USER GROUP

B & S:

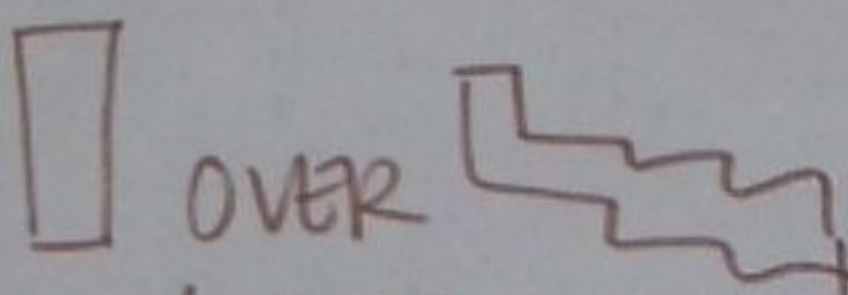
- 6 ELEVATORS - @ C.H.: 440', +10' (450'), 470' @ SOUTH.
- @ BACK OF HOUSE TO 3 FLOORS ABOVE & STORAGE BELOW - LARGER SIZE
